SUNDRY NOTICES AND REPORTS ON WELLS
Do not use this form for proposals to drill or to re-enter an abandoned well. Use form 3160-3 (APD) for such proposals.

8. Well Name and No.
JENKINS B FEDERAL 17

9. API Well No.
30-015-34138

Recomplete to the San Andres:

Jenkins B Federal # 17

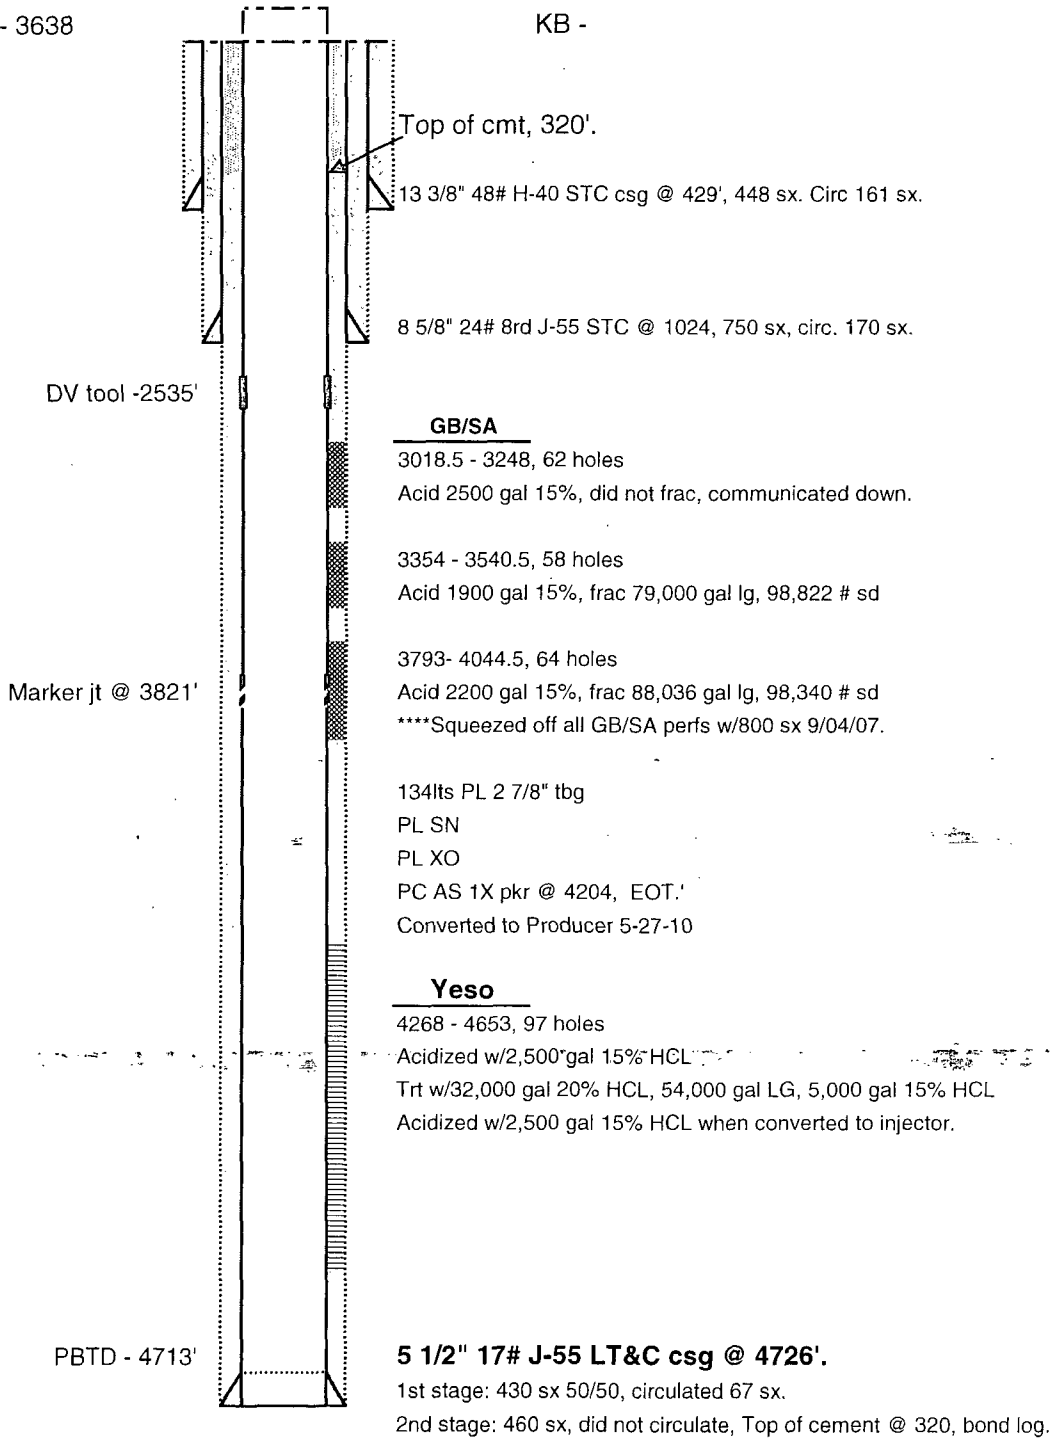
Can you please clarify where you are setting plugs. you say you will drill out plugs at 3300' and 3600' (Why are you setting them?). Diagram also say you are setting a CIBP at 4200'. Your procedure is a little unclear.

The plugs that are set at 3600' and 3300' are basically temporary frac plugs that are used for diversion during the frac/ acid job. The plug that is set at 4200', will be used long term both during the frac/acid jobs and during the production of the paddock zones. Hope that clarifies things, please let me know if y'all have any more questions.

Jenkins B Federal # 17

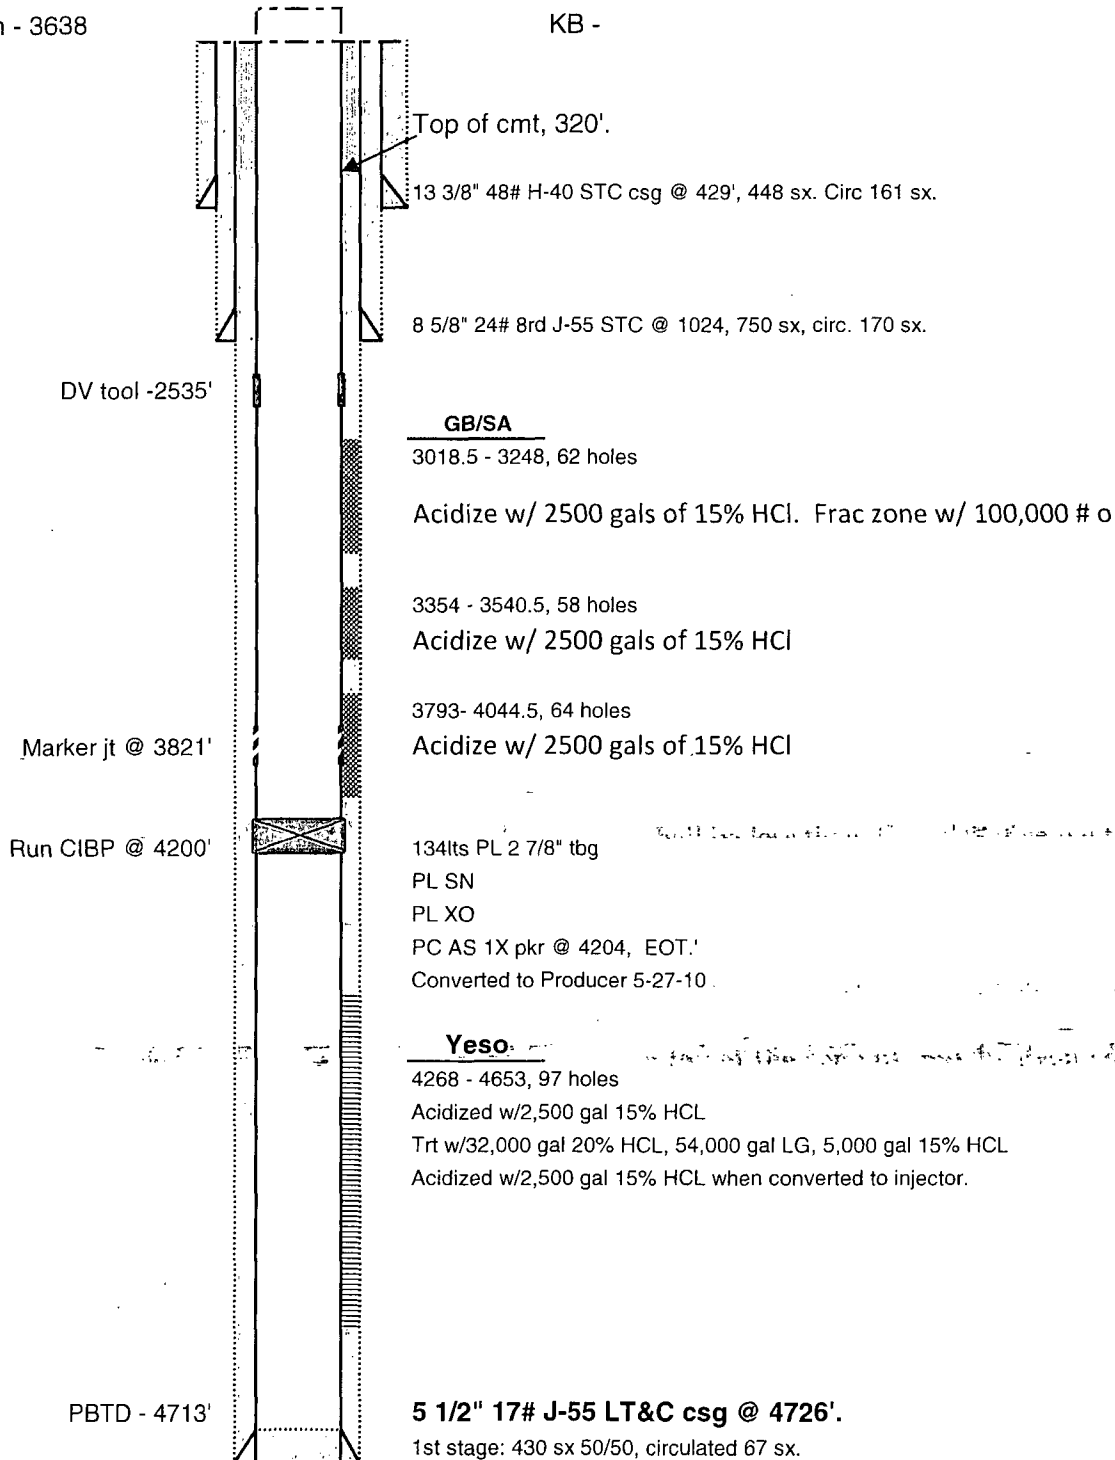
always include current & proposed wellbore diagrams.

- 1. Operator shall place 10 sx Class C Cement on top of the CIBP at 4,200'. Tag cement at 4,099'.**
- 2. Must conduct a casing integrity test before perforating and fracturing. Submit results to BLM. The CIT is to be performed on the production casing to max treating pressure. Notify BLM if test fails.**
